VILLAGE OF OSCEOLA PLAN COMMISSION MEETING

PLAN COMMISSION AGENDA

Re: C&E Wurzer Construction – 12 Unit Apartment Building

12-UNIT APARTMENT BUILDING SITE

SITE PLAN

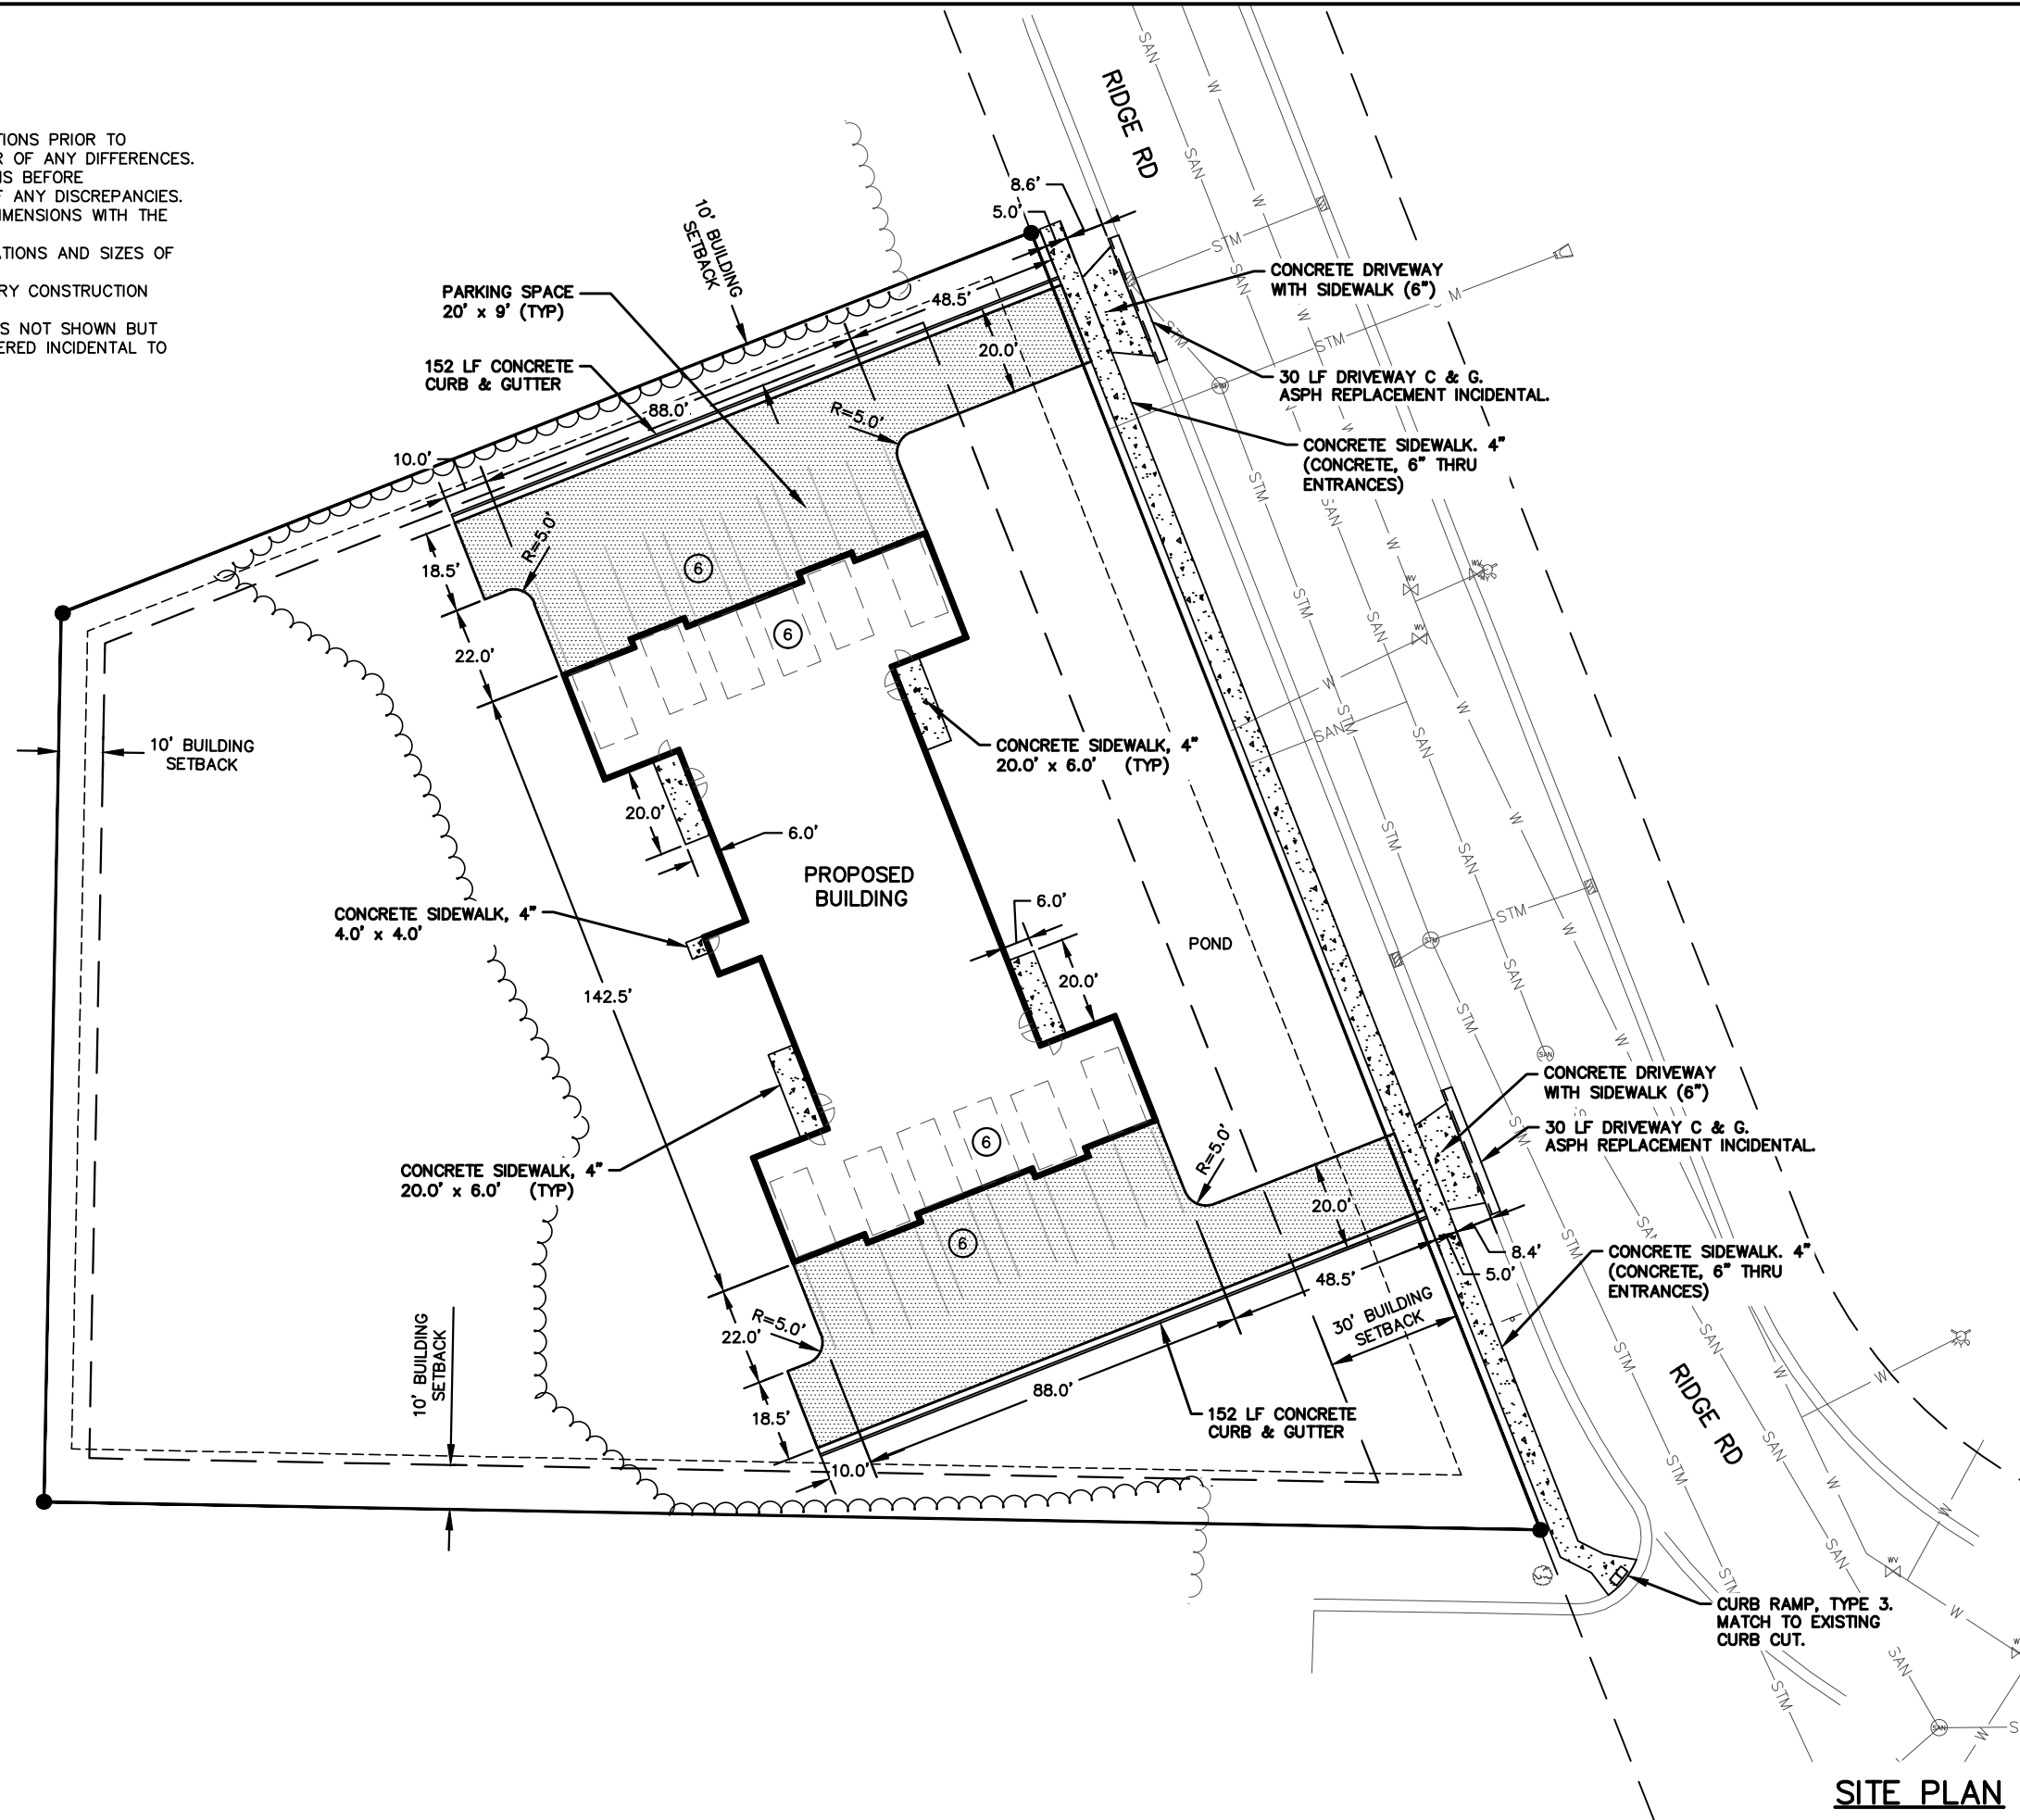
- A signage plan shall be submitted for review and approval. (9/25/2023) The developer has indicated that a sign will not be installed.
- A sidewalk needs to be extended along Ridge Road to connect with the sidewalk installed by Kwik Trip. (9/25/2023) A sidewalk along Ridge Road is shown on the revised civil plans.

- The existing storm sewer catch basin in Ridge Road falls in the north driveway. A new "drive-over" casting will need to be installed as part of the project. (9/25/2023) A drive-over casting is shown on the revised civil plans.

UTILITY PLAN

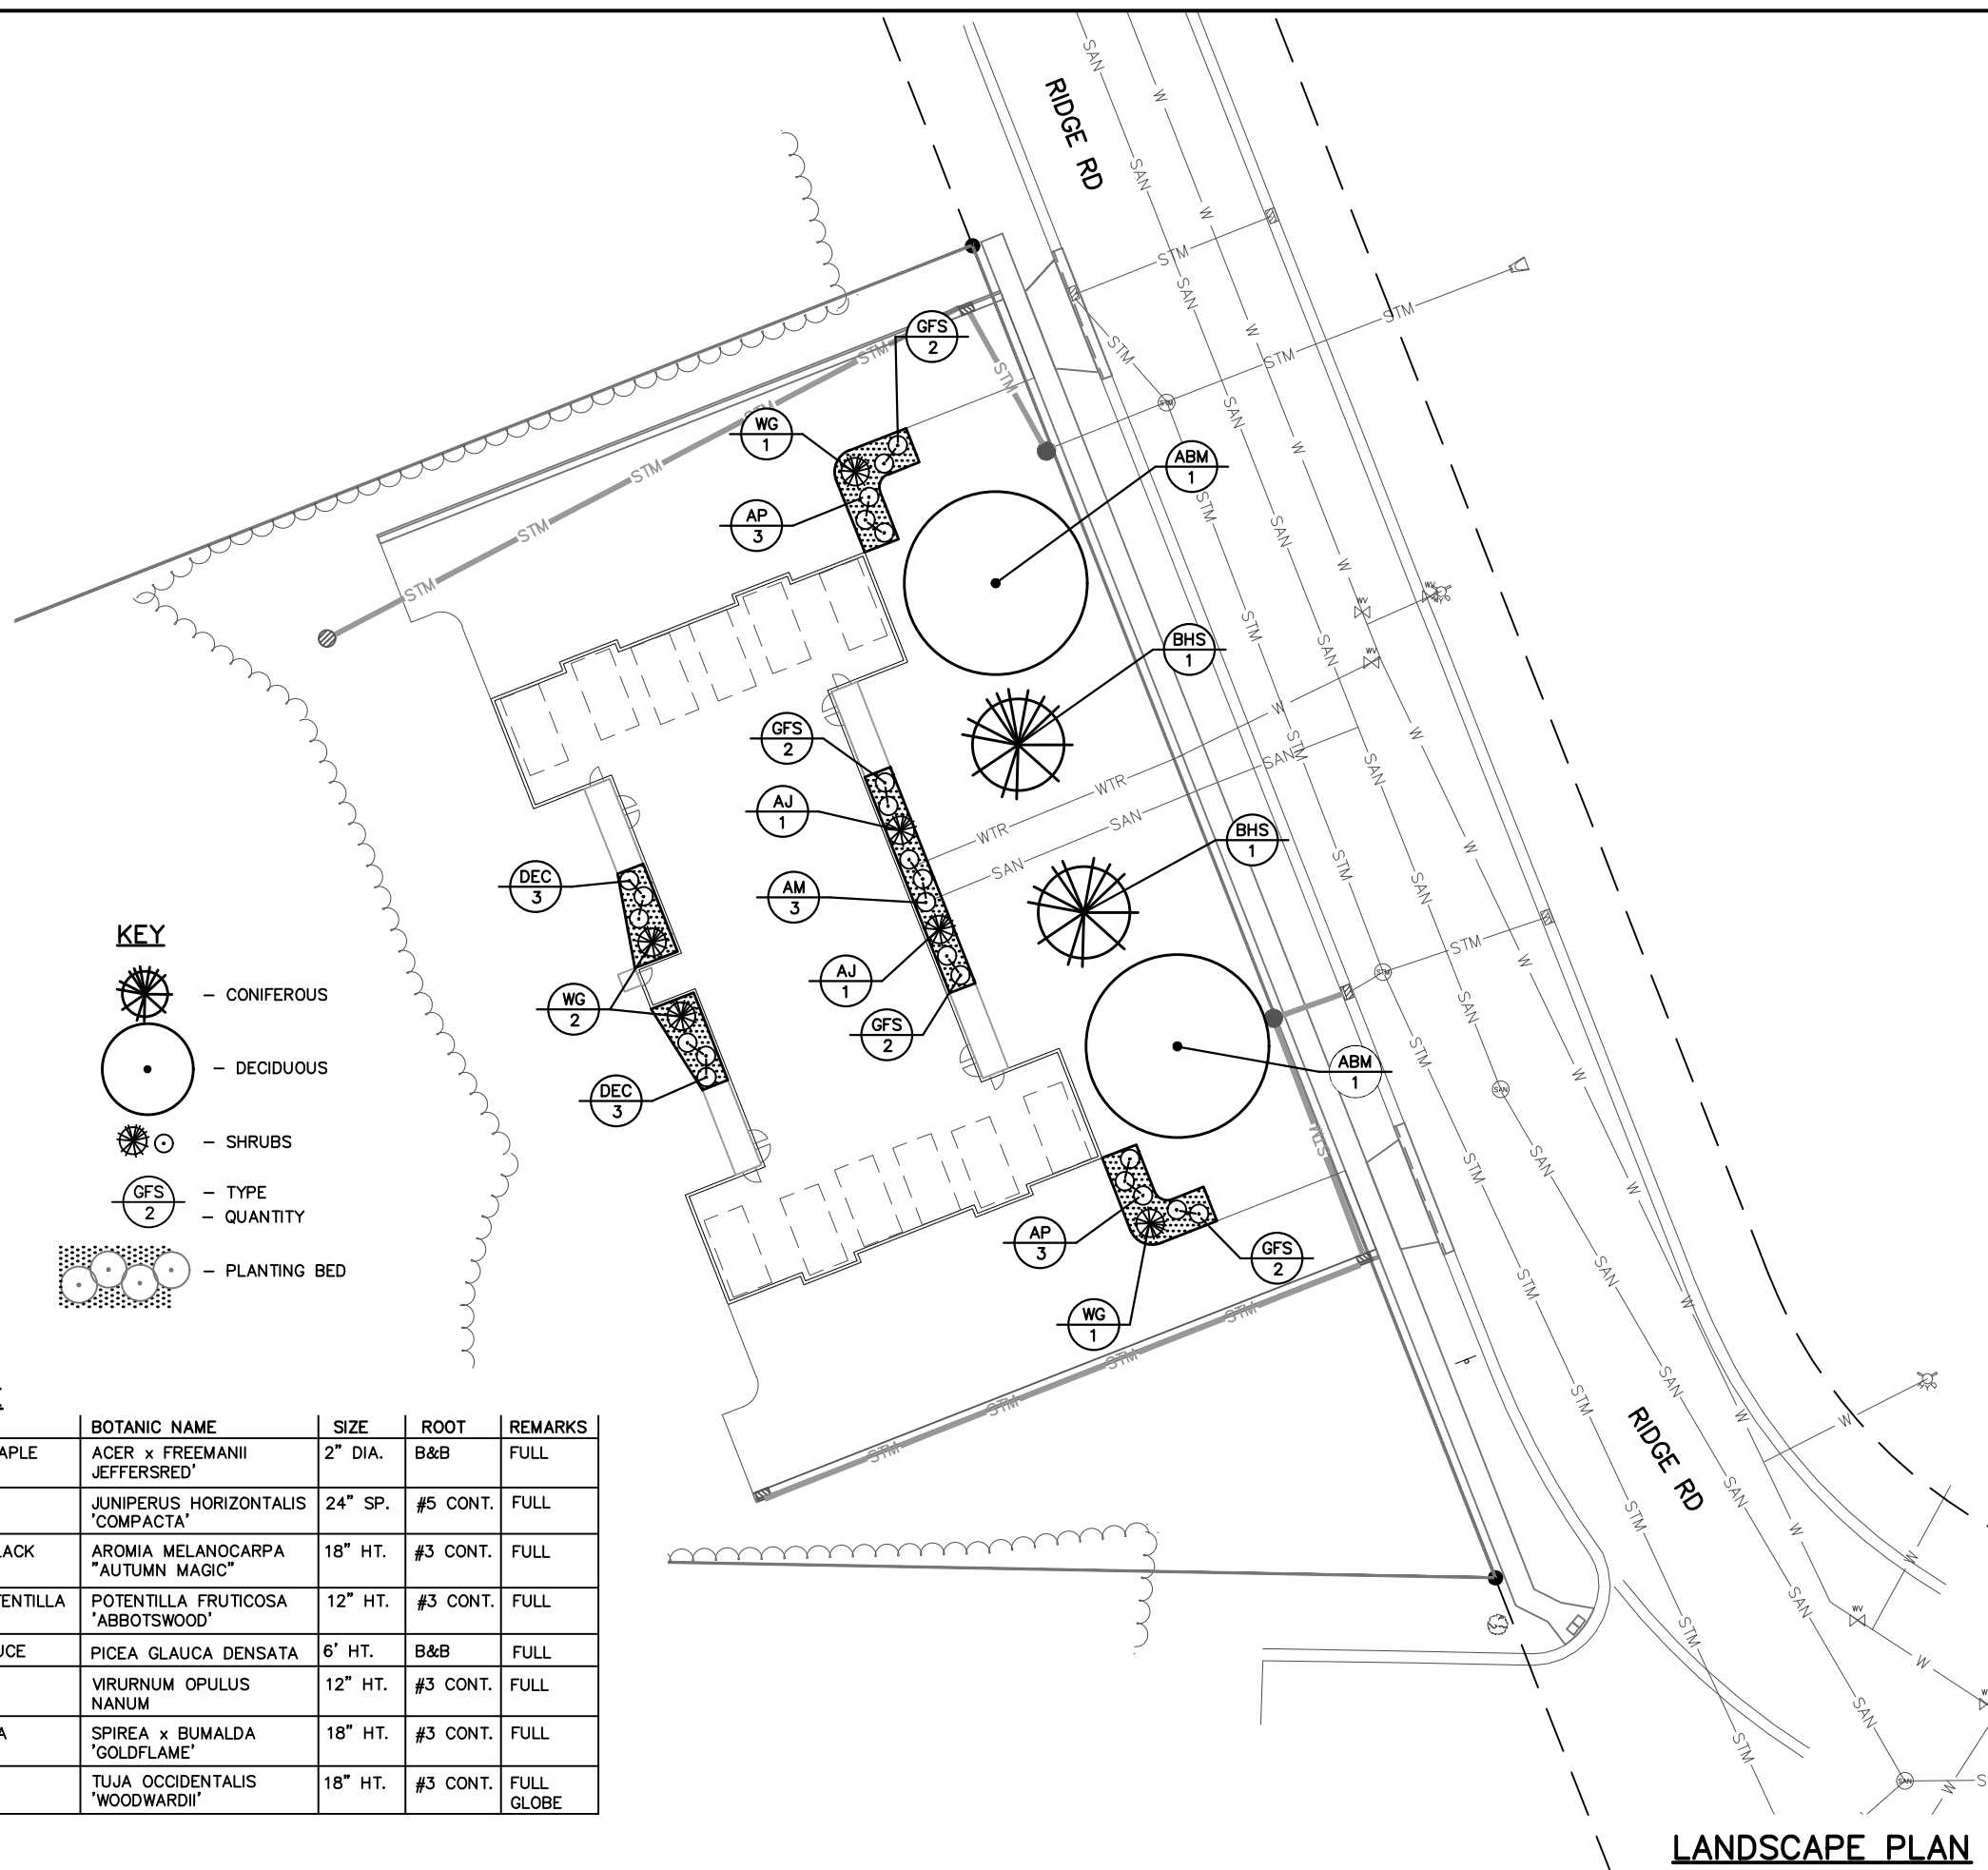
- (9/25/2023) The proposed plan shows a storm pipe connection to the existing catch basin in Ridge Road. There is an existing 15" storm sewer service stub provided for this lot near the north east corner of the parcel. To avoid the possibility of undermining the curb in the street when making the connection, all proposed storm sewer piping shall connect to the 15" storm sewer stub provided if the pipe capacity is sufficient for all of the site runoff.

LANDSCAPE PLAN

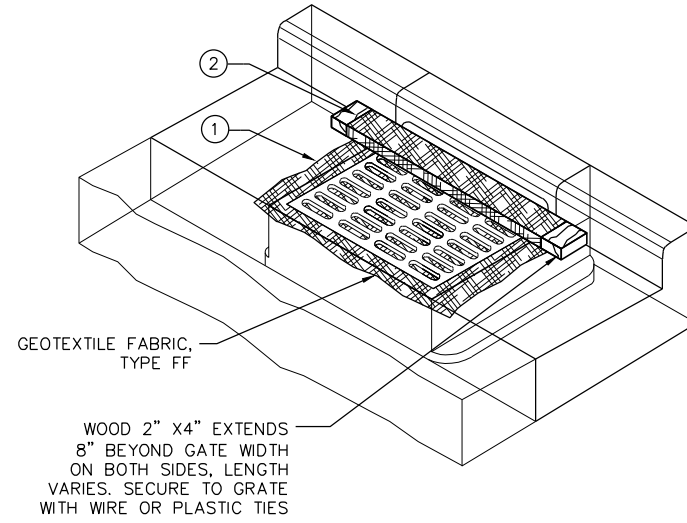
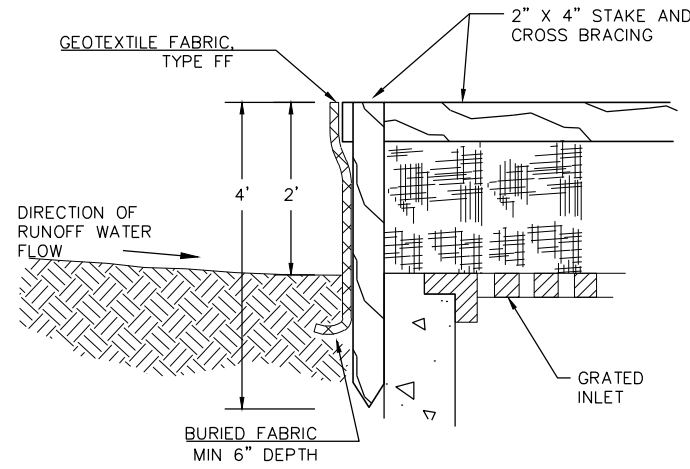
- A landscaping plan needs to be submitted for consideration and include planting types, quantities, layout and maintenance plan. (9/25/2023) The revised submittal includes a landscape plan.

CONCRETE DRIVEWAY W/ SIDEWALK
NO SCALE

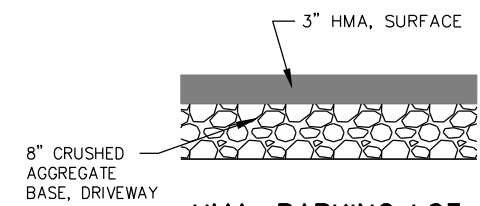
- Village of Osceola Standard Specifications and Details must be followed. Specifically, the driveway apron appears to not comply. (9/25/2023) The driveway detail shown on the revised civil plans is consistent with the Village Details. All work within the right-of-way will need to be completed in accordance with the Village Standard Details and Specifications.
